SUBJECT: U.S. NUCLEAR REGULATORY COMMISSION JUNE 3, 2009, ONSITE
OBSERVATION REPORT FOR THE SAVANNAH RIVER SITE SALTSTONE
FACILITY

U.S. NUCLEAR REGULATORY COMMISSION JUNE 3, 2009, ONSITE OBSERVATION REPORT FOR THE SAVANNAH RIVER SITE SALTSTONE FACILITY

Figure 1: ACI 117-06 Requirements

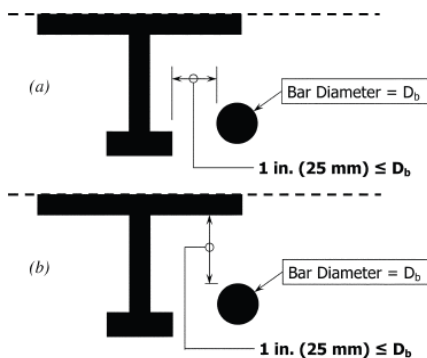
ACI 117-06, Section 2.3.1 (ACI, 2006) provides requirements for placement of embedded items and states “Clear distance to nearest reinforcement shall be the greater of the bar diameter or 1 in.” The commentary section R2.3 provides further clarification on this requirement with diagrams showing the clear distance should be from the embedment and the stud (Figure 1 shows the requirements designated by ACI 117-06 and Figure 2 shows a photograph of the closure strips used in disposal cell 2A [taken onsite during June 3 observation]).

Figure 2: June 3, 2009 Photograph of Closure Strip

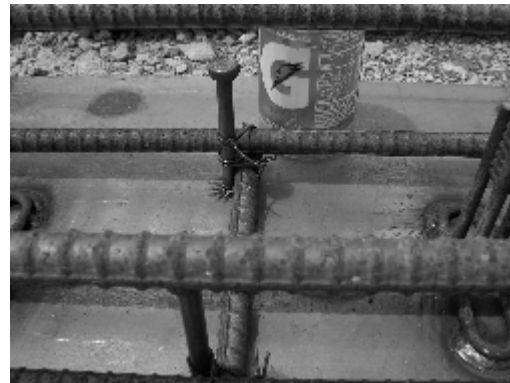
One of the intents of this requirement is to ensure proper concrete consolidation and bonding to all surfaces of the embedment and rebar and to prevent localized voiding issues. The steel closure strips were constructed with studs embedded in the concrete and rebar was placed less than 1" from these studs and in several instances actually in contact with the studs. Voiding issues of this sort could lead to preferential pathways within the disposal cell and could produce unforeseen weaknesses during the performance period. Given the potential for localized voiding created by this deviation, the staff recommends that DOE either confirm the absence of such voids or consider the potential for such voids in evaluating the performance of the cells.

DOE should either confirm the absence of voids caused by deviation from ACI 117-06, or consider the potential for such voids in evaluating the performance of the cells
